Product Change Notification

Date Issued :	December 19, 2023	PCN Number :	514557
Reason for Change :	Equipment Transfer, Production Transfer or Rearrangement		
Description of Change :	This notification is to inform you that Molex will be move molds and assembly line transfer. This PCN will move from Lincoln, Nebraska to Guadalajara, Mexico (site 2) and it was made to provide the best delivery to locally production products. We are starting these transfers in later Q3 2024. No product changes will be made as part of this change.		
Assessment of Change :	No change to parts - Form/Fit/Function		
Planned Implementation Date :	September 02, 2024		
Customer Sample Availability Date:	August 02, 2024		
Last date to request Samples by Customer :	July 01, 2024		
Please note if Samples are not requested as per Customer Samples Request date, it may take additional 4-6 weeks to arrange Samples.			
Traceability Code Markings / Date :	Date code

Exploded Bom

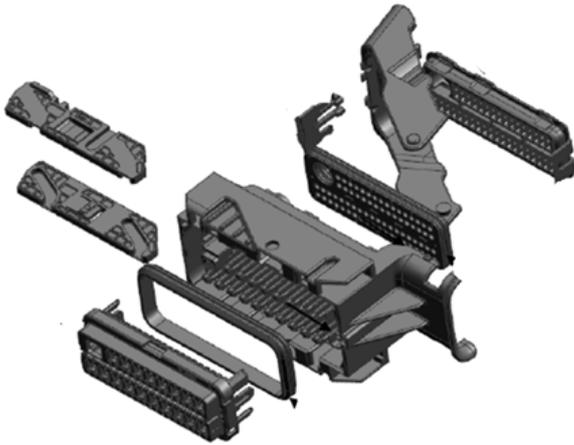
- Molex will be moving molds and assembly line. This move will be from Lincoln, Nebraska to Guadalajara, Mexico (site 2) and was made to provide the best delivery to local production products.

Guadalajara 2

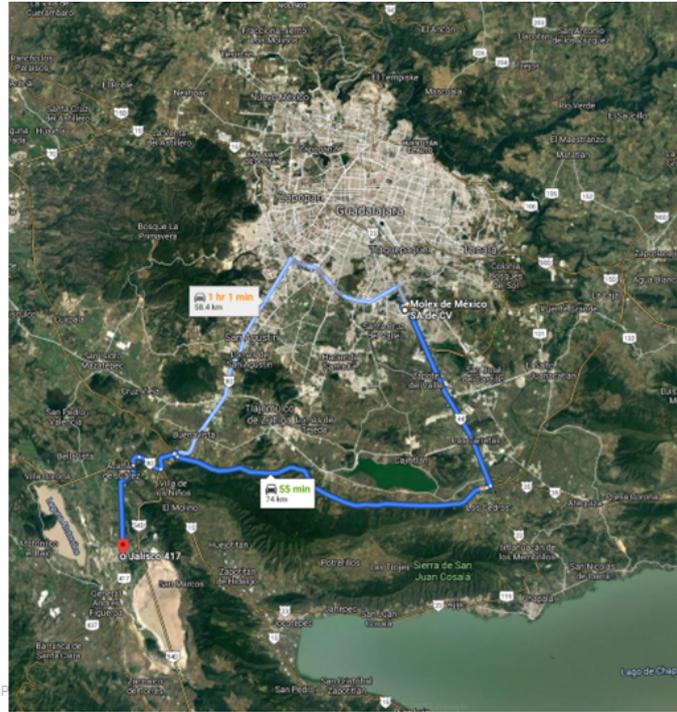
- Located in Centro Logistico Jalisco Industrial Park
- 1 hour from existing Quad1
- Initial build will contain Molding, Assembly, and Reliability Testing capabilities
- A new Distribution Center services Quad2
